AR-07-1802

Southern Nuclear Operating Company
Vogtle Early Site Permit Application
Response to Request for Additional Information Involving
Limited Work Authorization-2 Supplement

Response to October 26, 2007 RAI Letter No. 9

Vogtle ESP Application Involving LWA-2

Plot of N_{60} and V_s with Elevation

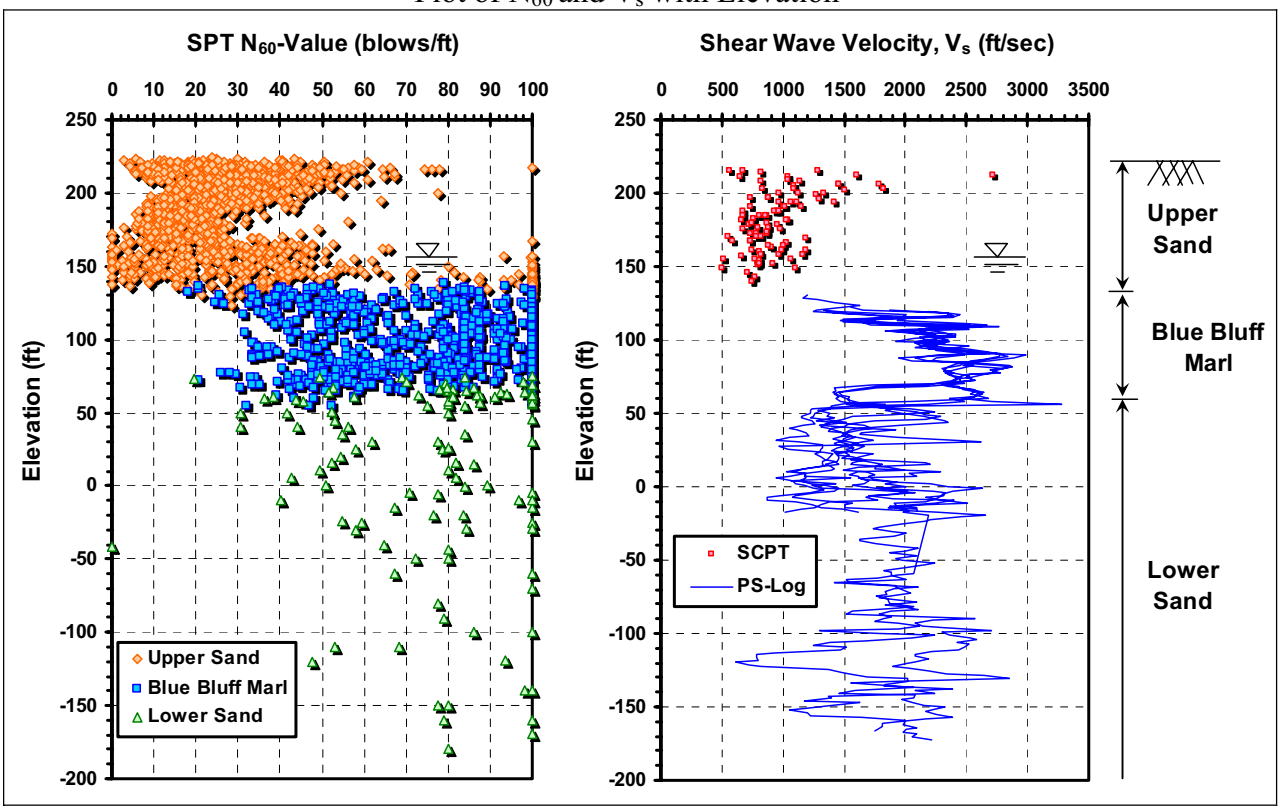
2.5.4-2 In its previous reviews conducted for the early site permit (ESP) application, the staff was concerned with the number of borings that penetrated significantly into the Blue Bluff Marl (BBM), the layer offering primary support to the Nuclear Island (NI). Without additional information concerning the depths and numbers of all these penetrations, the staff is unable to address whether the mean properties of site stratigraphy are adequately being modeled and whether enough properties were determined to be able to adequately determine material property variability; SNC is requested to provide a description of those borings that penetrated into and through the BBM and how many samples and types of samples were taken of this material as well as material below the BBM.

As stated in response to RAI 2.5.4-1, 70 borings were taken in the power block area; 42 of these borings penetrated the Blue Bluff Marl (BBM) accounting for 2,831 linear feet of drilling in this stratum. Seven hundred and forty-two SPT split barrel samples (disturbed samples) were obtained in the BBM. The SPT N_{60} values and shear wave velocity measurements in these borings are presented in the figures below. SPT blow count data are also summarized in the table below. From these SPT data, the average measured N-value is 70 bpf with a median value of 72 bpf. The average N_{60}-value is 96. Nearly all of the SPT N_{60} values from the BBM are greater than 30 bpf. Ninety-four relatively undisturbed samples were taken in the BBM. Laboratory tests were conducted on selected disturbed and undisturbed samples. A summary of these test results is also provided in the table found on page 6.

B-4001 UD-4

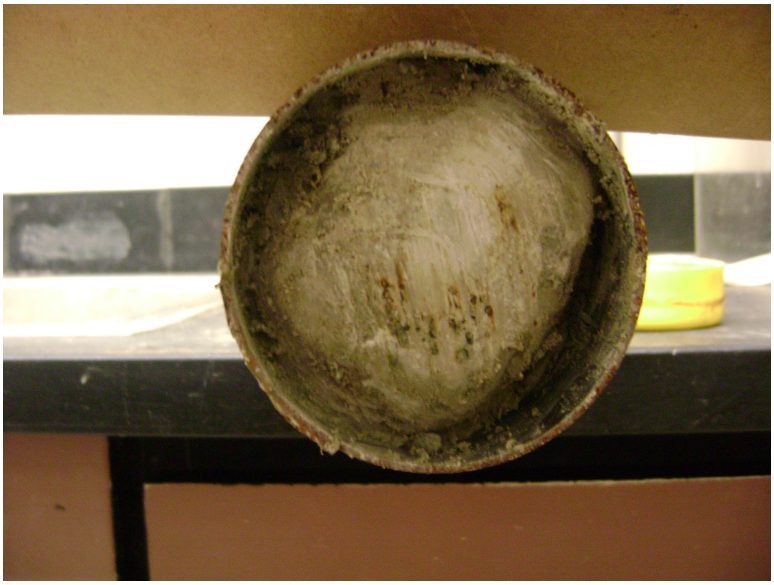
2.5.4-3 Since the BBM material is important to the foundation support and site response, SNC is requested to demonstrate the ability to understand how samples of the BBM were obtained and how the degree of disturbance of this material was evaluated during the testing program.

In summary, the degree of disturbance was evaluated visually once the sample was extruded. Those samples not visually disturbed were tested, otherwise they were discarded. Disturbance was kept to a minimum by controlling the sampling, transportation, storage, and extruding/handling in the laboratory. However, the very heterogeneous structure of the BBM probably resulted in significant disturbance of the sample during sampling and extrusion in many instances.

Shear Wave Velocity Measurements in the Upper Sand Stratums Measured by COL SCPTu

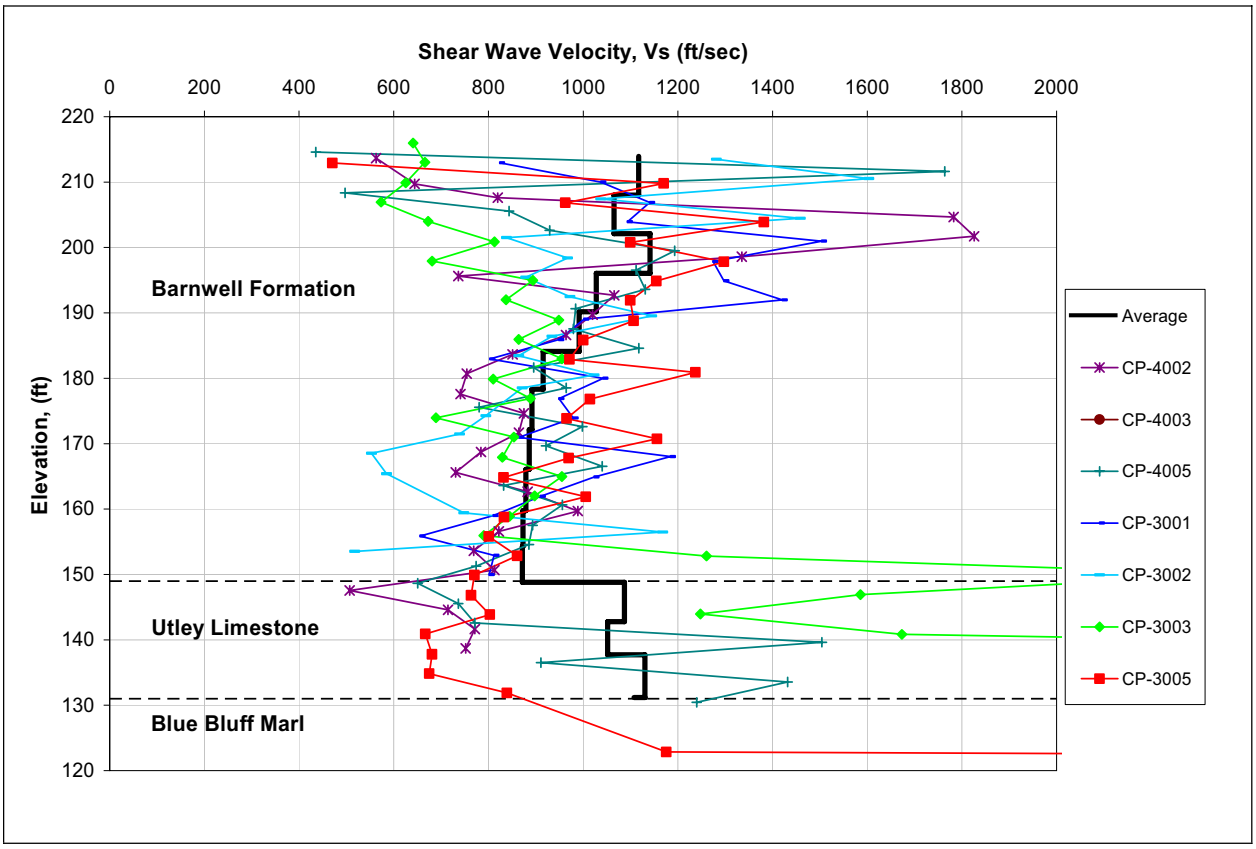
2.5.4-4 Section 2.5.4.2.2.1 indicates that no new strength (and presumably stiffness) testing is to be performed for the Upper Sand Strata since this material is being excavated from beneath the Category I structures. Without additional information, the staff cannot verify SNC's conclusion on the effect of the two-dimensional velocity configuration of the excavated zone on site response and SSI effects. SNC is requested to provide the assessment of the in-situ velocity profile through the Upper Sand Strata for the staff to complete its evaluation.

Shear wave velocity data were collected in the Upper Sand in the power block/cooling tower area. Eight SCPTu soundings were taken as described in the above response to RAI 2.5.4-1. The shear wave velocity measurements from seven of these soundings along with the average velocity profile are presented on the figured below. The data from the eighth sounding, C-4001, was not plotted and incorporated into the average value. In this sounding velocity values of 4,000 fps were encountered at the top and bottom of the US stratum and the data were judged to be unreliable.

Modulus Reduction Curves for EPRI and SRS Models

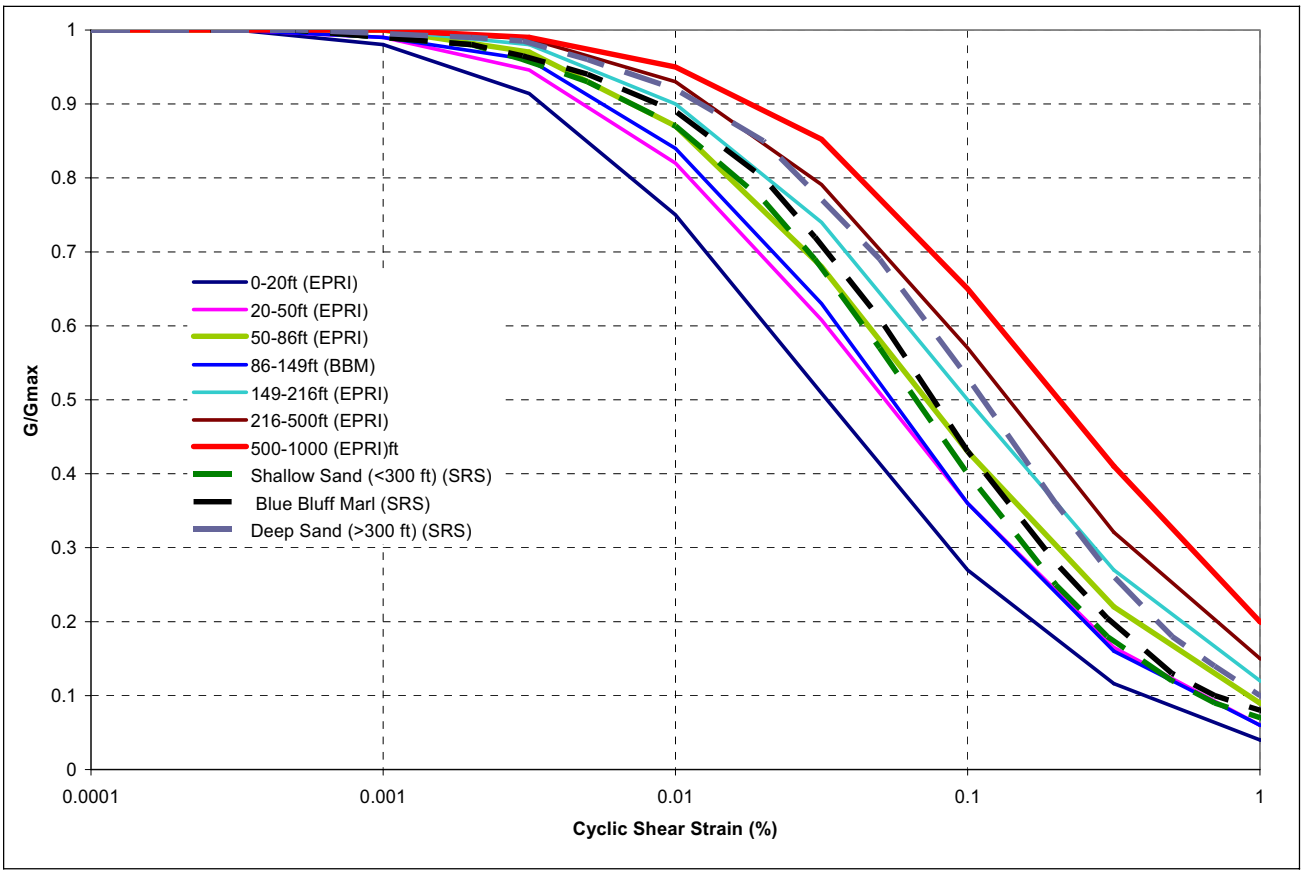
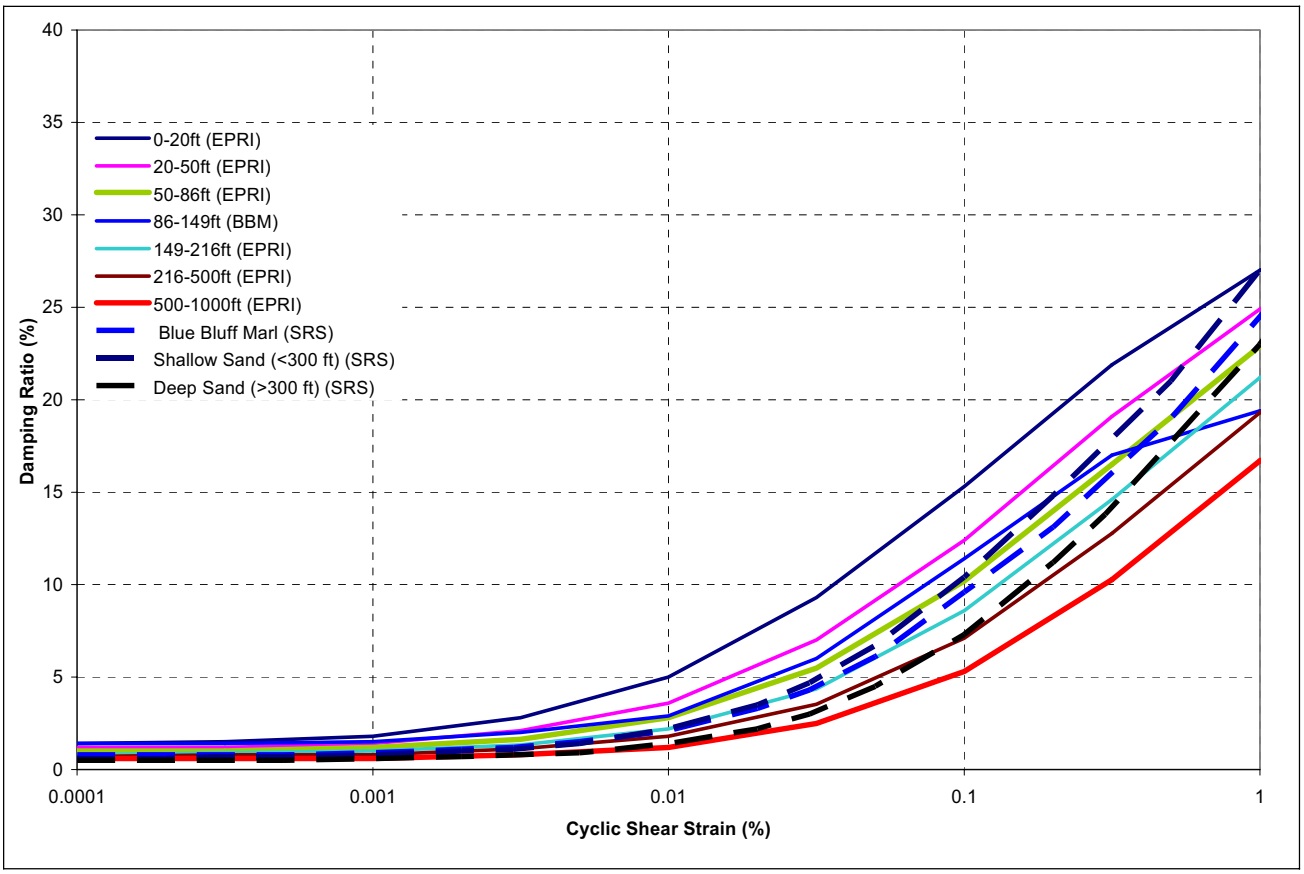
2.5.4-16 In Subsection 2.5.4.7.1, SNC discussed the shear wave velocity profile to characterize the site, but the discussion did not cover the backfill material. In Subsection 2.5.4.7.2, SNC described EPRI 1993 soil degradation models as well as SRS models. However, no significant discussion is presented of how these two models compare, which is more appropriate to use for Vogtle site response analyses, and how significant the models are to both site response and SSI analyses. SNC is requested to address these three issues.

2) ESP application Subsection 2.5.4.7.2 discusses shear modulus and soil damping for the compacted backfill, BBM, and Lower Sand strata. These subjects were further discussed in the March 15, 2007 response to RAI 2.5.4-17. These discussions included descriptions of which EPRI curves were used to derive the soil degradation values for input to the SHAKE analysis. Soil degradation values from the neighboring SRS site were also used for input to SHAKE. Figures 2.5.4-9 and 2.5.4-11 in the ESP application illustrate the EPRI soil degradation values, while Figures 2.5.4-10 and 2.5.4-12 illustrate the SRS soil degradation values. The modulus reduction curves for EPRI and SRS have been plotted together in the figure below to illustrate the relationship between these models. Likewise, the same has been done for the damping ratio curves. Note that the SRS curves were selected based on their stratigraphic relationship to the Vogtle 3 and 4 site. The SRS curve labeled as Blue Bluff Marl on the figures below is

based on the Dry Branch Formation and the Santee Formation, the SRS stratigraphic equivalent to the Vogtle Blue Bluff Marl Both data sets were used to include variability in the model and each is weighted equally. RCTS testing is currently being conducted to develop site-specific data. When these data become available, the results will be evaluated and the site response analysis will be re-run if appropriate.
